Vermont Agency of Transportation
RECEIVED
 CK'D BY RKJW OK'D BY JS
 September 26, 2013

RESUBMIT NO Approved AsNoted
 BY KH DATE 10-25-2013

PRECAST CONCRETE BOX CULVERT SHOP DRAWINGS (SDI JOB #13510)
 SUPERVISOR: M. WHEELER
 DETAILER: C. DUPLANTIS
 CHECKER: M. WHEELER
 ENGINEER: ENGINEERING VENTURES

Plan View

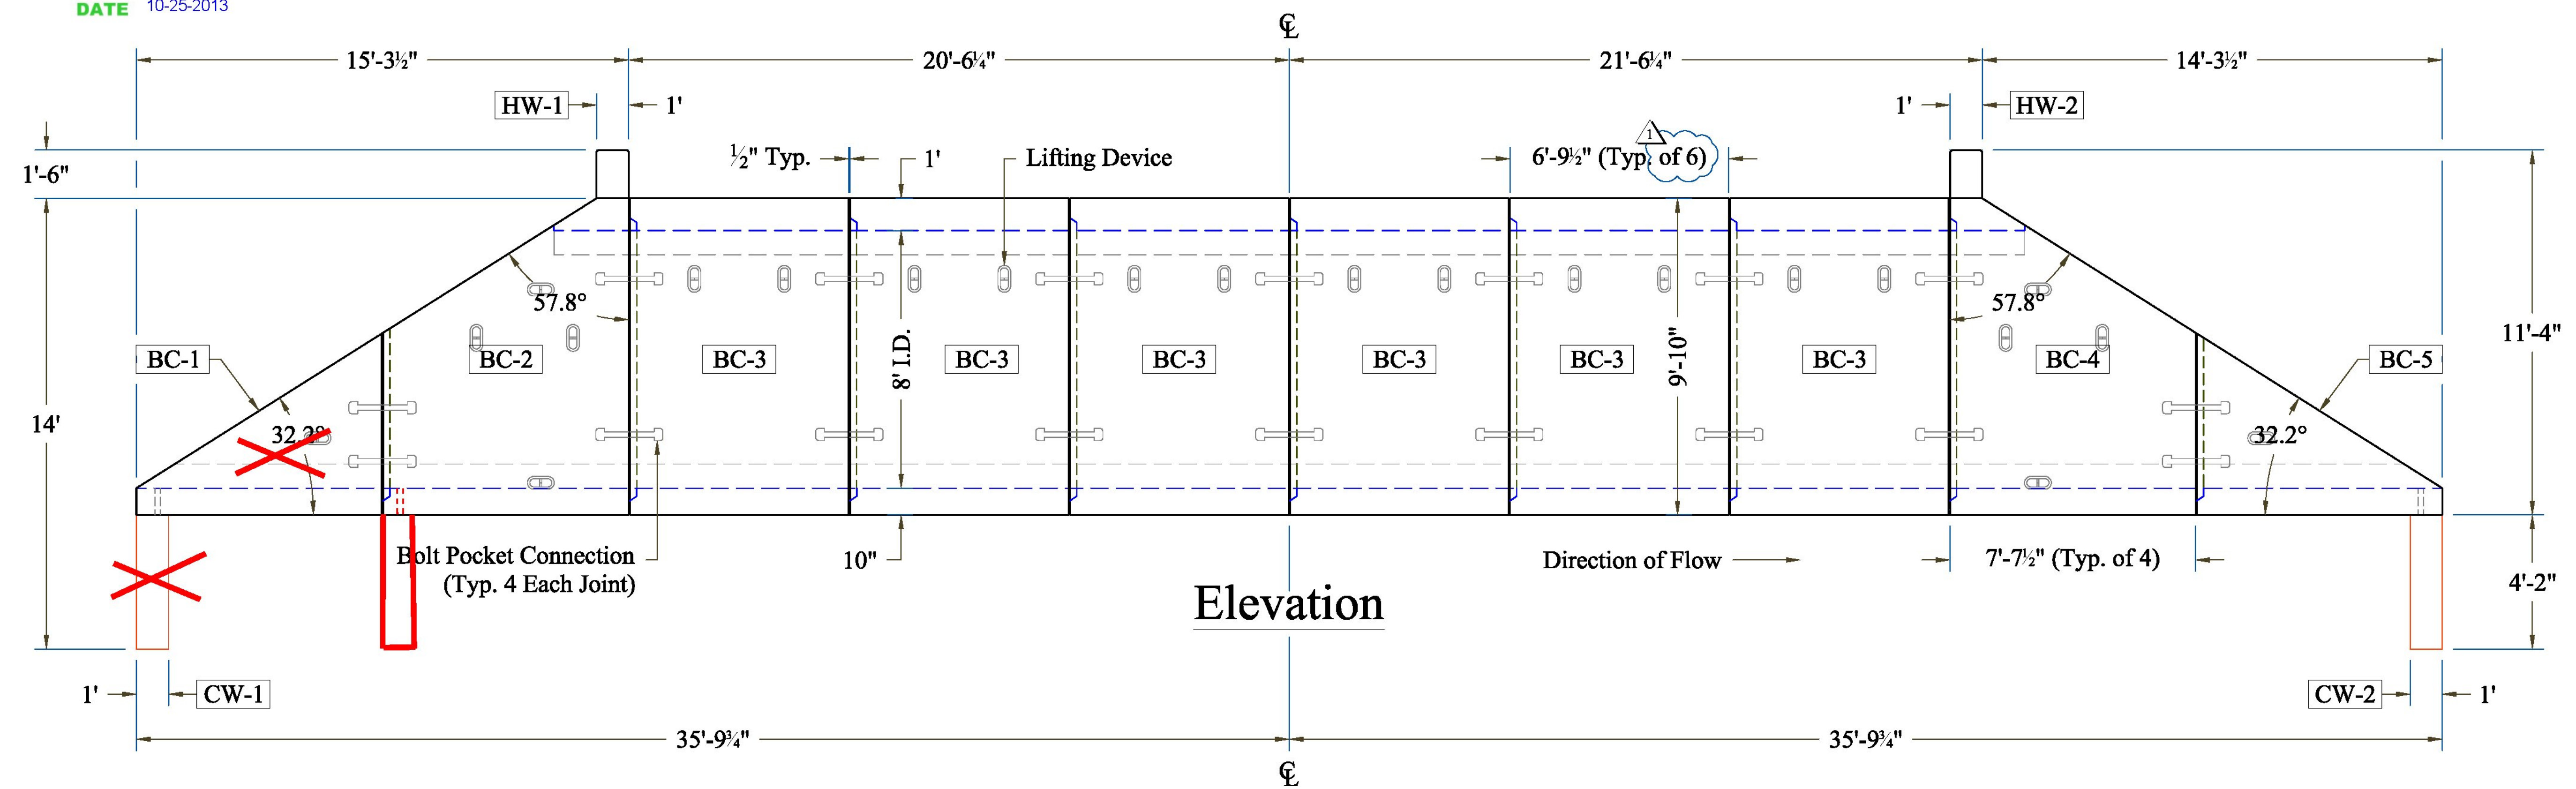
REVISED 10-25-2013 JTS
 BC-1 HAS BEEN OMITTED AND WILL NOT BE FABRICATED.
 HOLES FOR FOR DOWELING CUT OFF WALL SHALL BE ADDED TO BC-2
